Product Change Notice Ref: (Winstar OLED/Jan19)

Please be aware of the following Product Change Notice issued by Winstar Display.

New Module

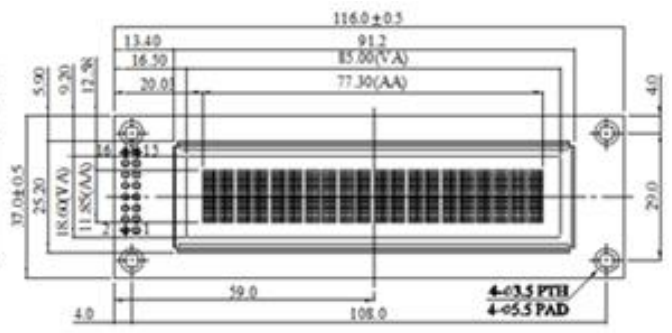
The bezel change is to aid assembly. There will be no change to electrical or optical characteristics.
